Customer : CU-DAR001 Dart Helicopters Services	Drawing Name : HELI UTILITY BASKET LH/RH 350/355
Job Number : 39050	
Estimate Number : 10208	
P.O. Number :	Part Number : D350607043
This Issue : 05/05/2008 S.O. No. :	Drawing Number : D350-607 REV F P7-9
Prsht Rev. : NC	Project Number : N/A
First Issue : / / Type : LARGE FAB ASSY	Drawing Revision : F
Previous Run : 39018	Material :
Written By :	Due Date : 30/05/2008 Qty: 1 Um: Each
Checked & Approved By : <u>JUD 08.5.05</u>	
Comment : Est Rev:E as Per DSI9318 06-01-24 JLM Est Rev:F ECN1068 07-12-21 DD verified by:

Drawing Name: HELI.UTILITY.BASKET.LH/RH 350/355

Customer	: CU-DAR001 Dart Helicopters Services	Drawing Name	: BASKET LID ASSEMBLY
Job Number	: 39050A		
Estimate Number	: 10206		
P.O. Number	:	Part Number	: D2989041
This Issue	: 05/05/2008 S.O. No. :	Drawing Number	: D2989 UNDER REVIEW
Prsht Rev.	: NC	Project Number	: N/A <i>08.05.05</i>
First Issue	: / / Type : LARGE FAB ASSY	Drawing Revision	: B
Previous Run	: 39018A	Material	:
Written By	:	Due Date	: 30/05/2008 Qty: 1 Um: Each
Checked & Approved By	: <i>JUD 08.5.05</i>		
Comment	: Est Rev:l Removed D2989-043 05-11-03 JLM

DESIGN <i>CP</i>	DRAWN BY <i>CP</i>	DART AEROSPACE LTD HAWKESBURY, ONTARIO, CANADA	
CHECKED <i>[Signature]</i>	APPROVED <i>[Signature]</i>	DRAWING NO. DSI 9318	REV. A SHEET 1 OF 1
DATE 06.01.06		TITLE WASHER ADDITION	SCALE NTS
A	06.01.06	NEW ISSUE

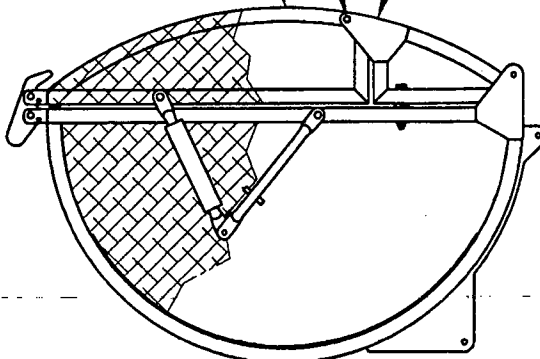
To reduce the possibility of damaging the finish, a **NAS1515H4** washer (2 places) has been added between the hinge plate and basket frame on the **D350-607-043/-047 Heli-Utility-Basket**.

The corrected bolt stackup from Figure 5 of installation instructions D350-607 Rev. F is given below:

AN4-13A BOLT (1)
AN960JD416 WASHER (1)
HINGE PLATE (REF)
NAS1515H4 WASHER (1)
BASKET FRAME (REF)
AN960JD416 WASHER (1)
MS21042L4 NUT (1)
(2 PLACES)

DESIGN DS	DRAWN BY PH	DART AEROSPACE LTD HAWKESBURY, ONTARIO, CANADA	
CHECKED <i>[Signature]</i>	APPROVED <i>[Signature]</i>	DRAWING NO. D2989	REV. B SHEET 1 OF 3
DATE 05.06.07		TITLE BASKET LID ASSEMBLY	SCALE NTS
A	00.10.27	NEW ISSUE	
B	05.06.07	ADD SHIM UNDER HINGES, UPDATE LID DIMENSIONS

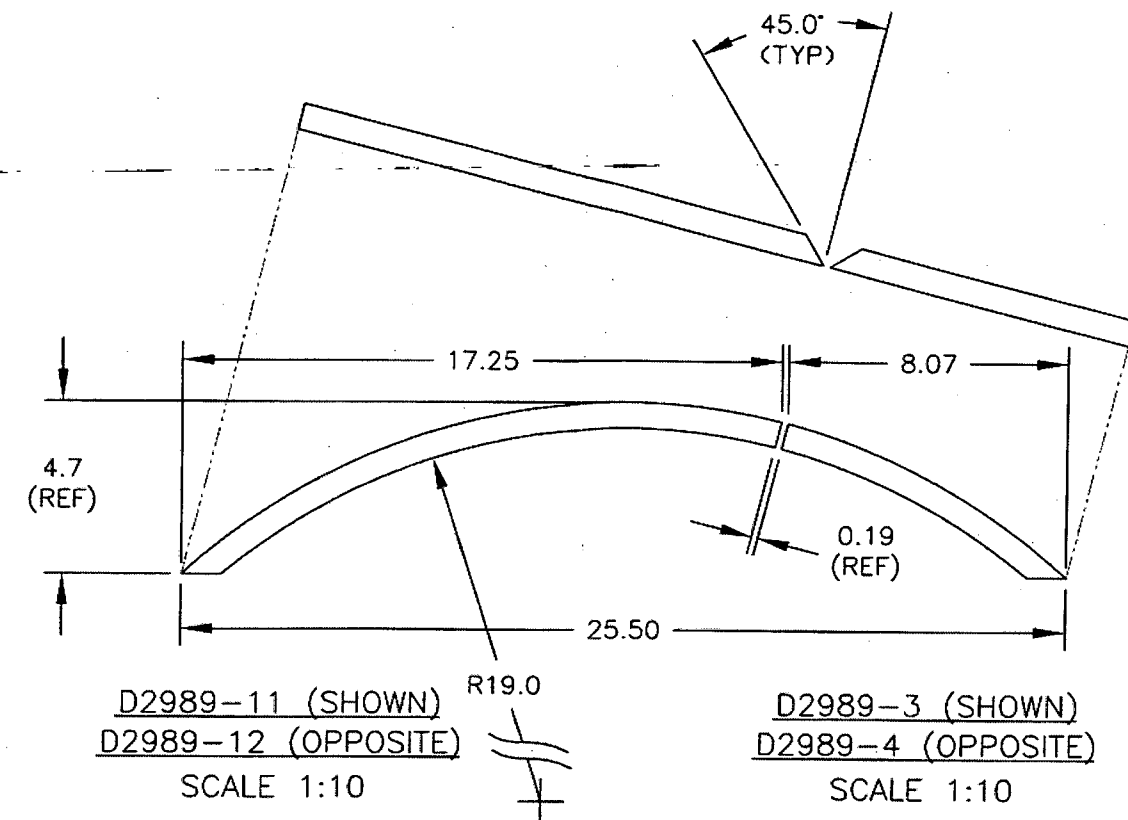
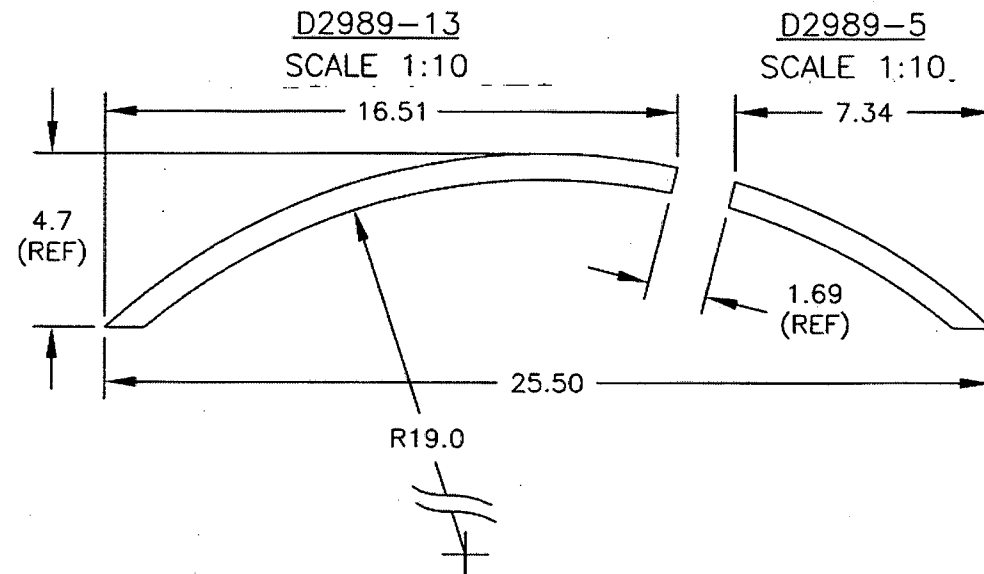
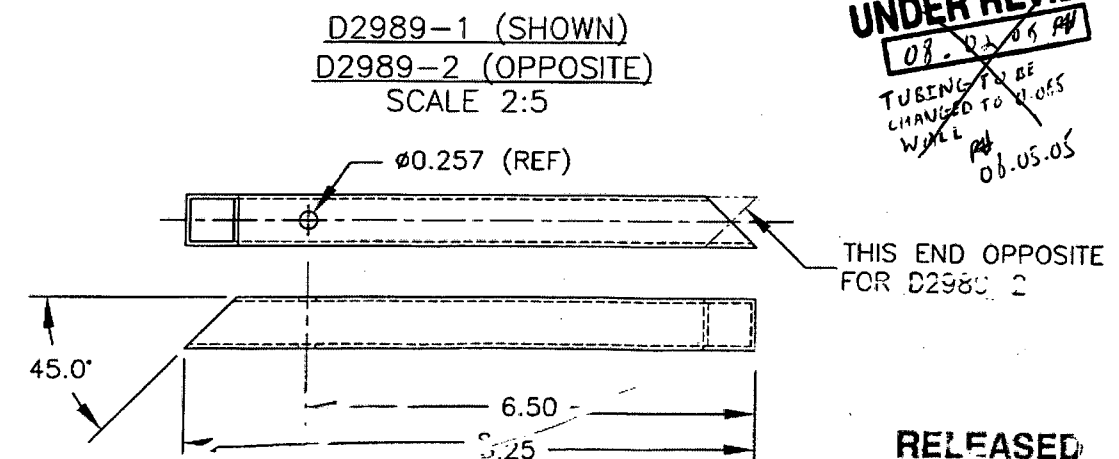
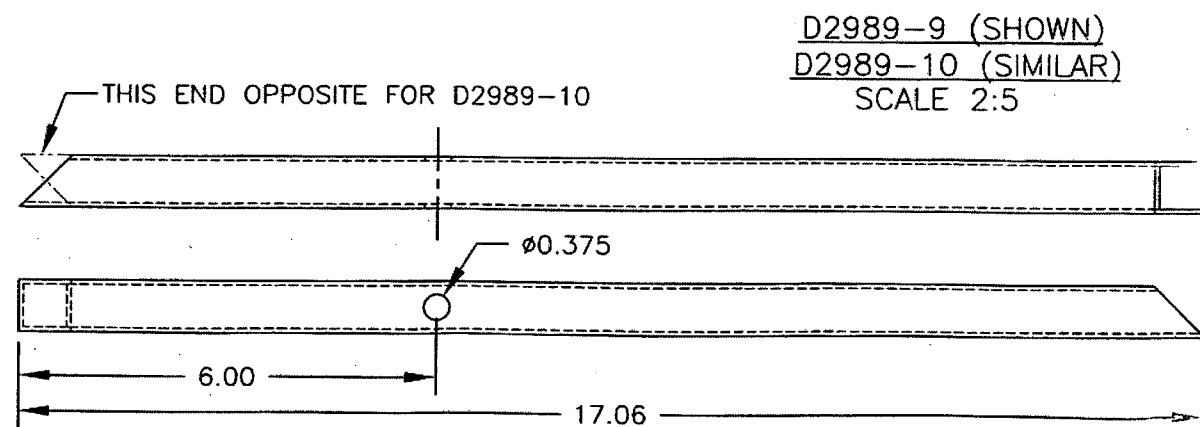
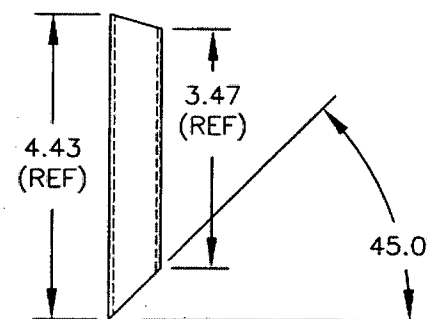
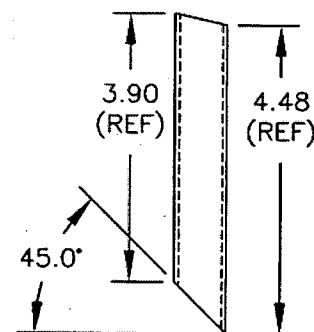
08.02.05 *[Signature]*
TUBING TO BE
CHANGED TO 0.065
WALL *[Signature]*
06.05.05

DESIGN DS	DRAWN BY PH	DART AEROSPACE LTD HAWKESBURY, ONTARIO, CANADA	
CHECKED <i>[Signature]</i>	APPROVED <i>[Signature]</i>	DRAWING NO. D2989	REV. B SHEET 1 OF 3
DATE 05.06.07		TITLE BASKET LID ASSEMBLY	SCALE NTS
A	00.10.27	NEW ISSUE	
B	05.06.07	ADD SHIM UNDER HINGES, UPDATE LID DIMENSIONS

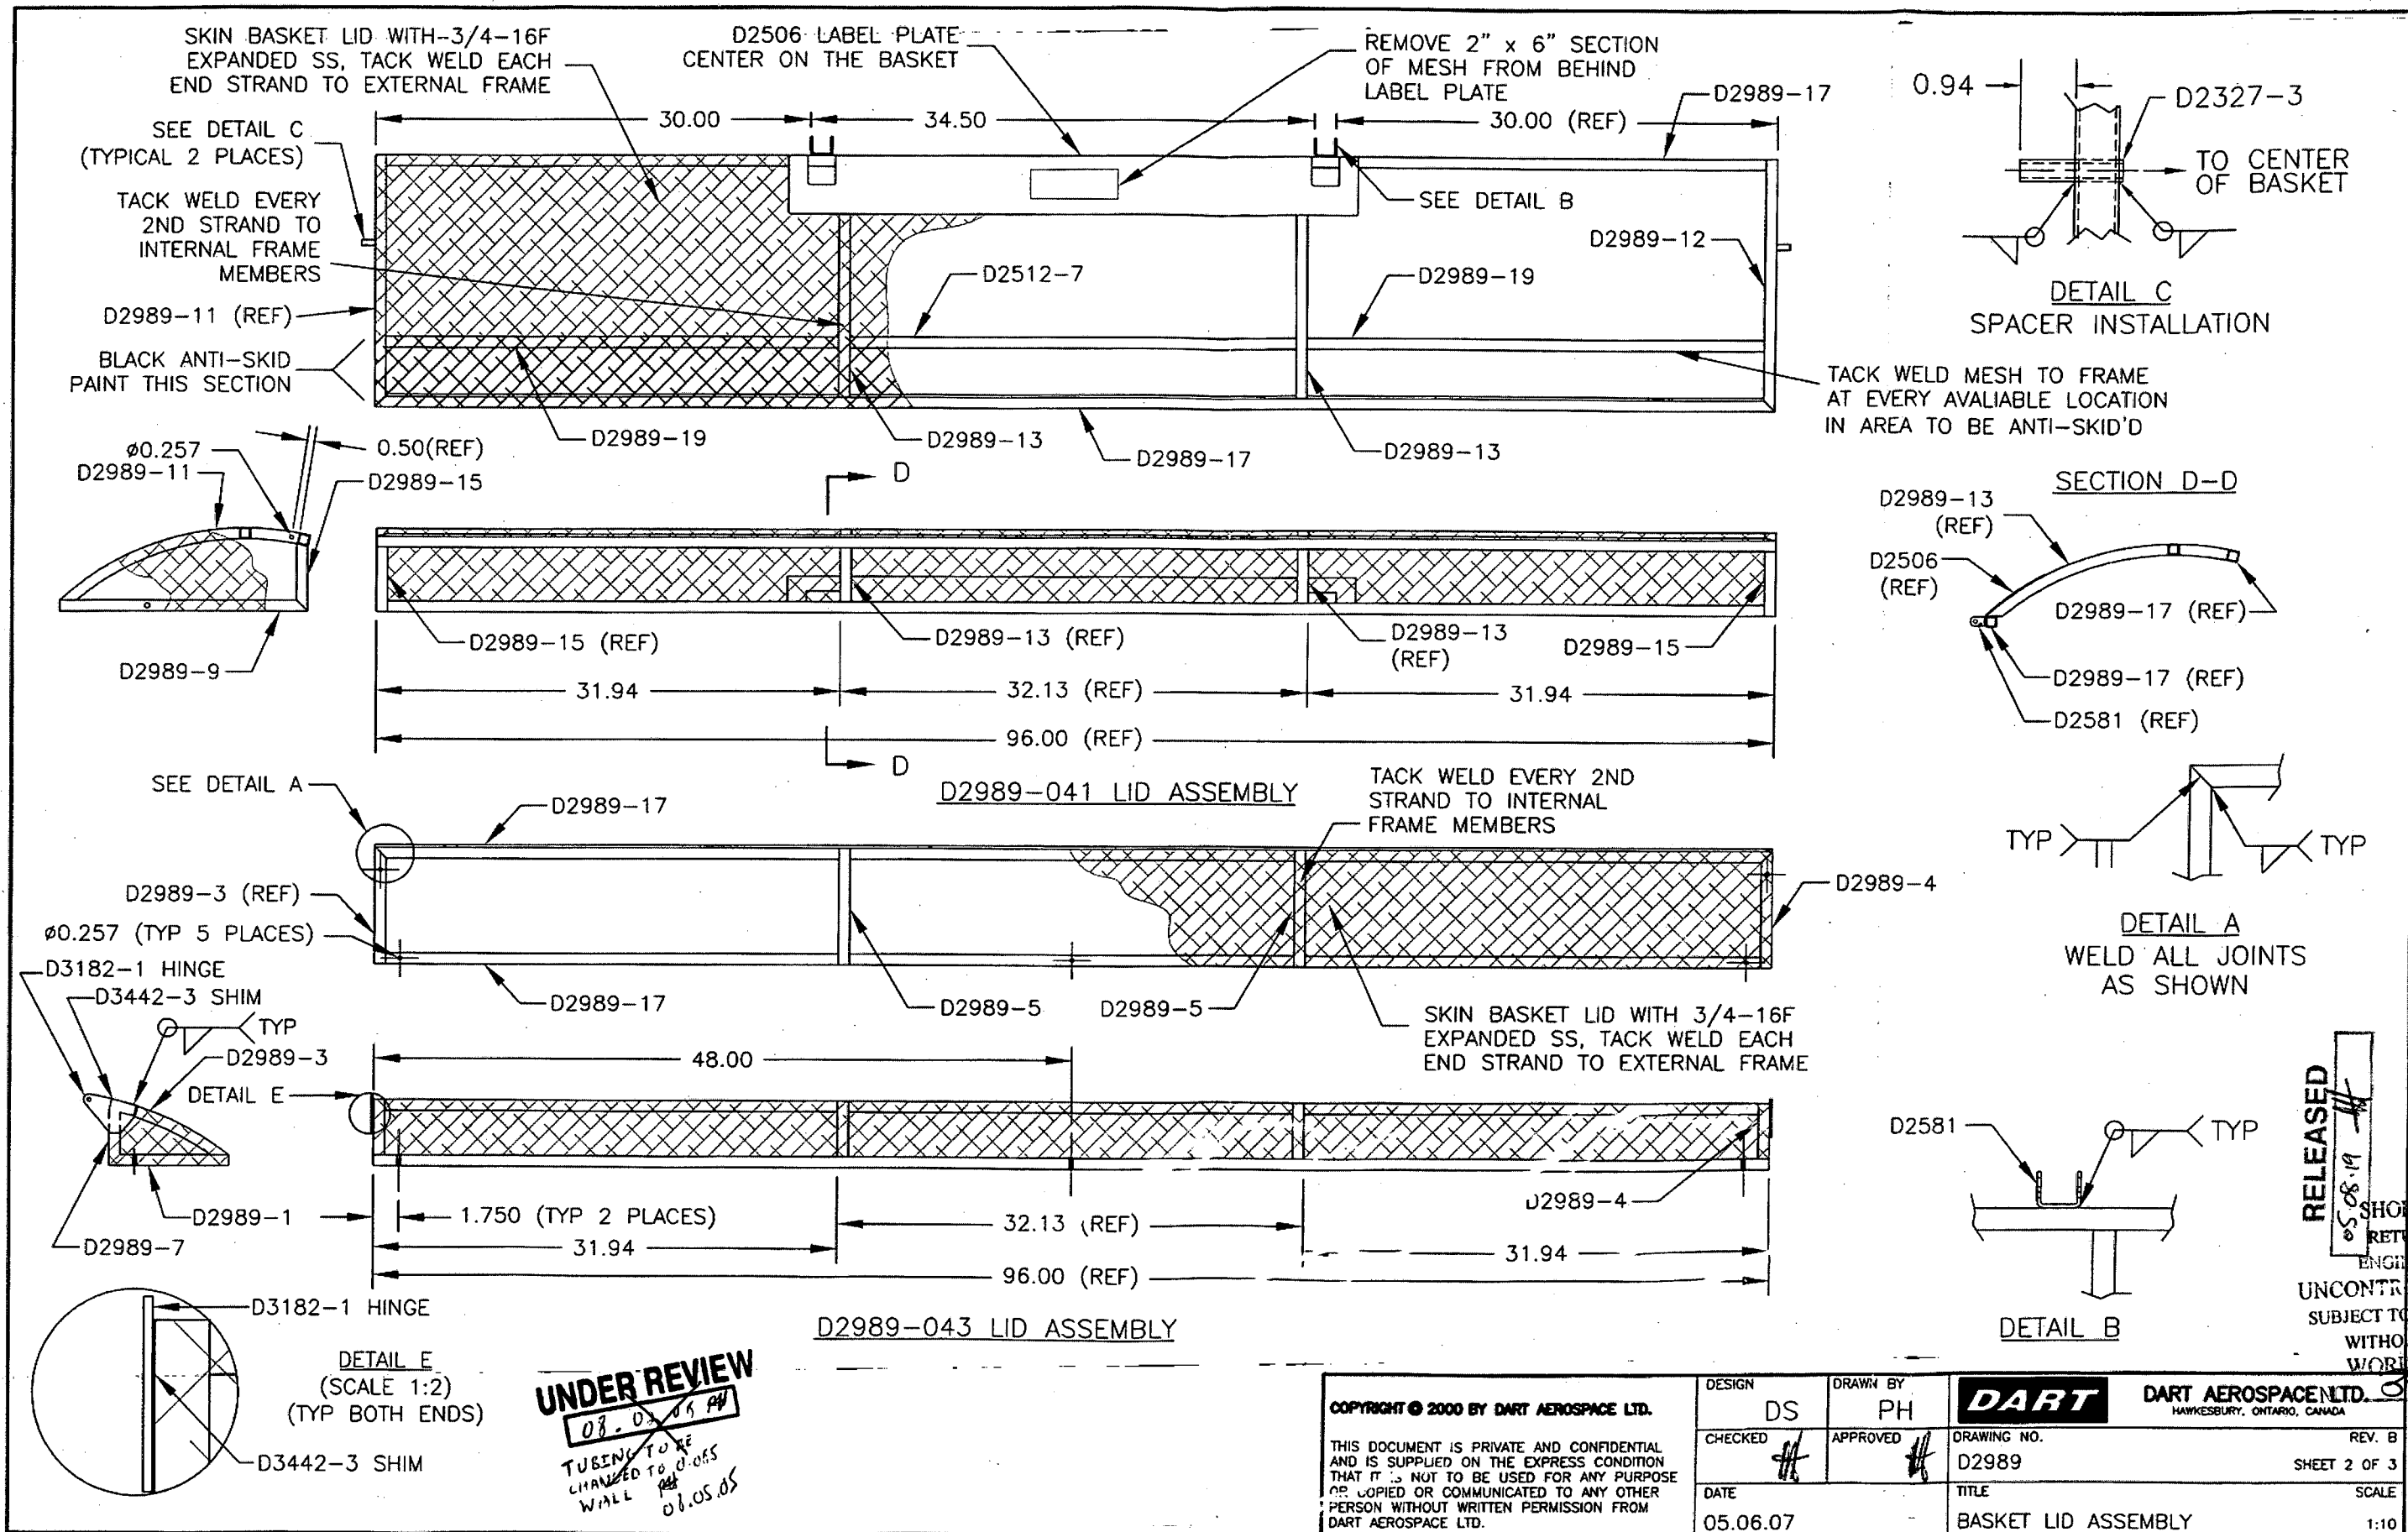
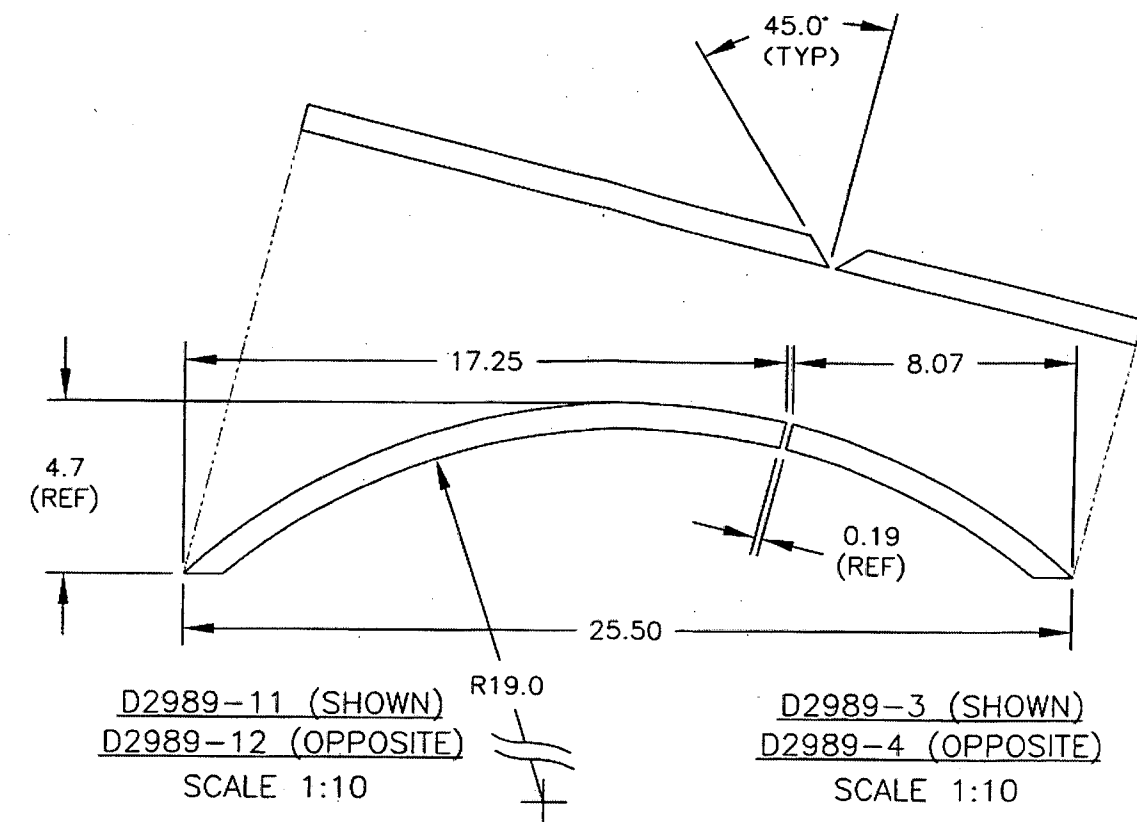
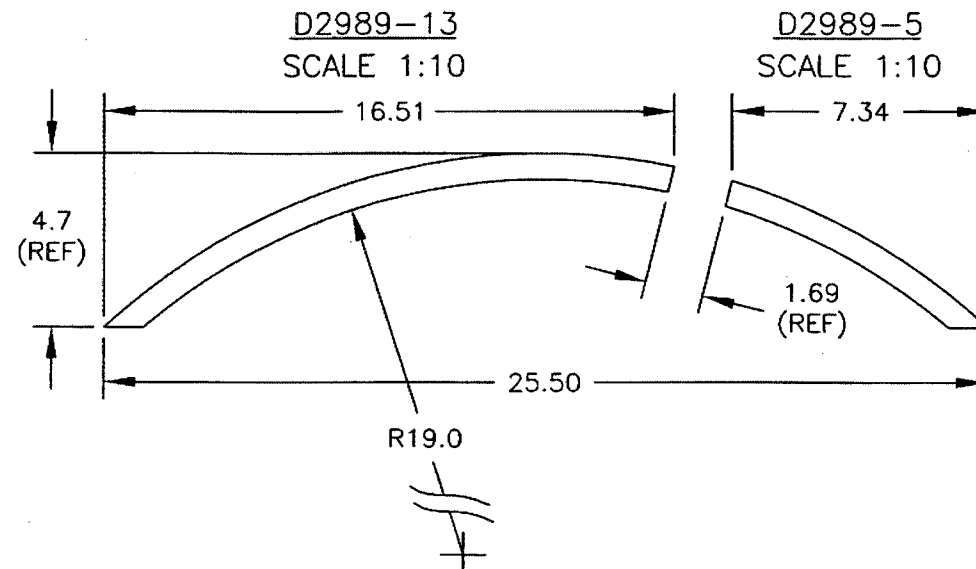
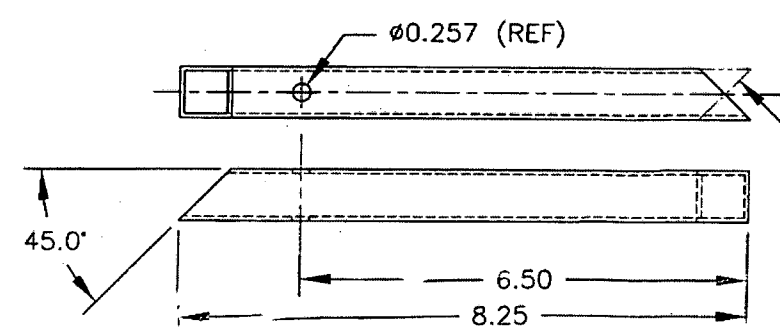
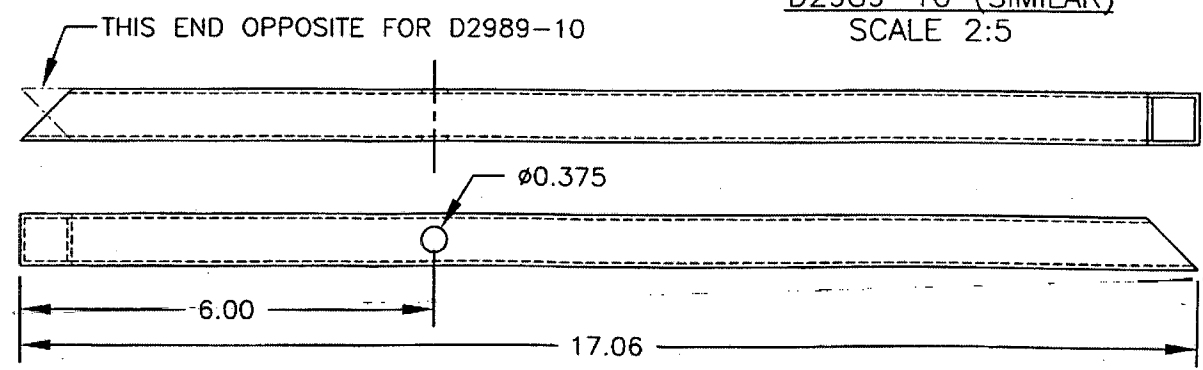
UNDER REVIEW
08.05.05 PH
TUBING TO BE
CHANGED TO Ø0.065
WALL PH
03.05.05

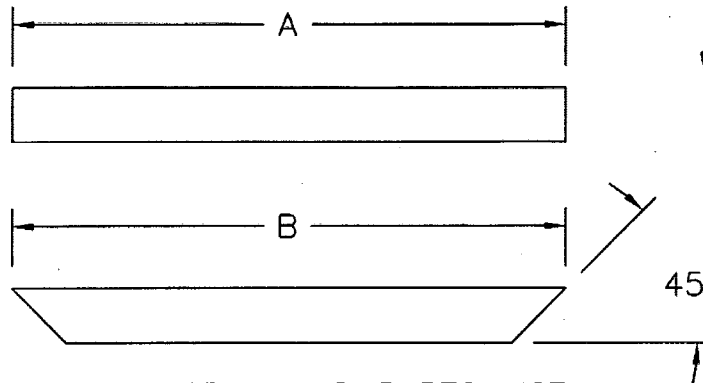
UNDER REVIEW
08.02.05 *H*
TUBING TO BE
CHANGED TO 0.065
WALL
SHOP COPY
RETURN TO
ENGINEERING
UNCONTROLLED COPY
SUBJECT TO AMENDMENT
WITHOUT NOTICE
WORK ORDER
NO. 390506

DESIGN BW	DRAWN BY PH	DART AEROSPACE LTD HAWKESBURY, ONTARIO, CANADA	
CHECKED 	APPROVED 	DRAWING NO. D2221	REV. F SHEET 3 OF 3
DATE 05.06.07		TITLE BASKET BASE ASSEMBLY (350)	SCALE 1:8

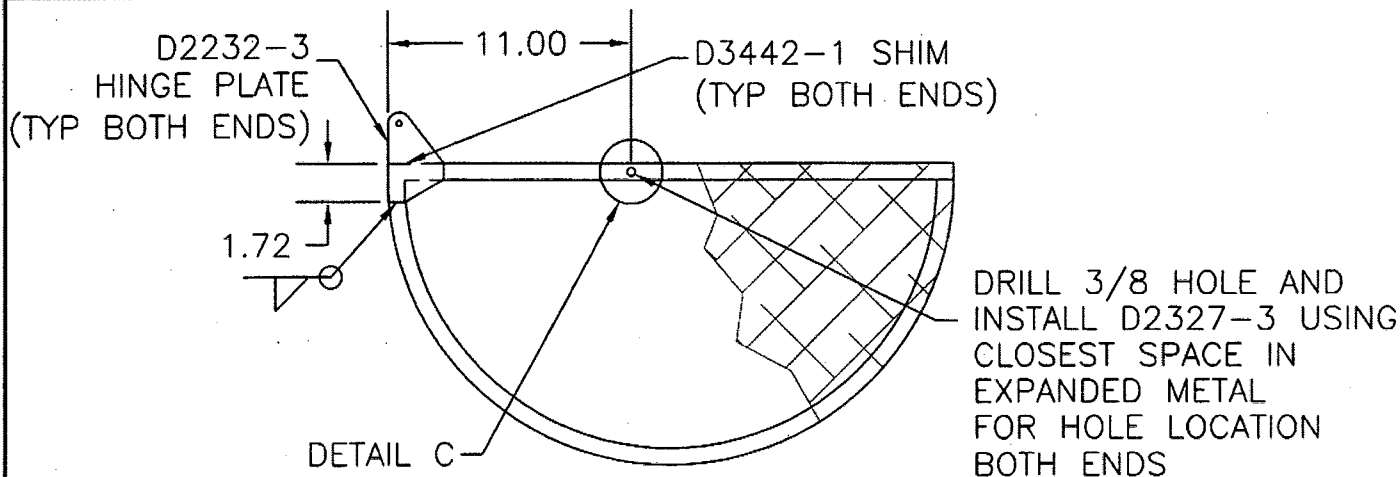
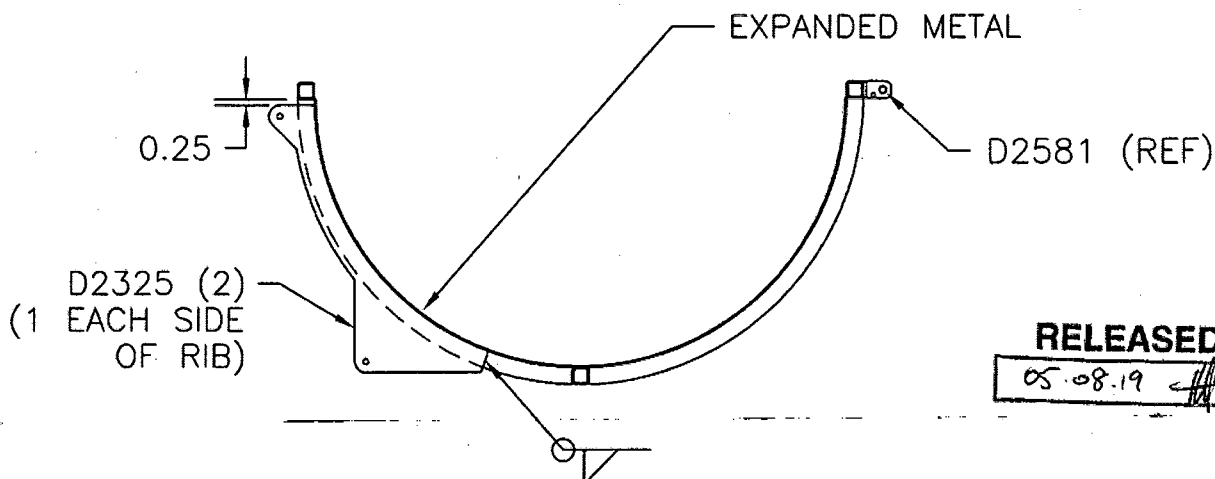
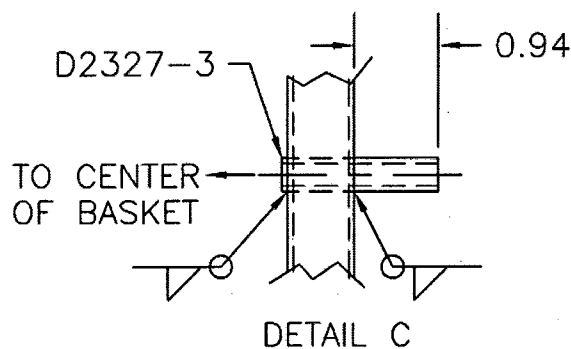
08.02.08 PH
TUBING TO BE
CHANGED TO CROSS
WALL PH
06.05.05
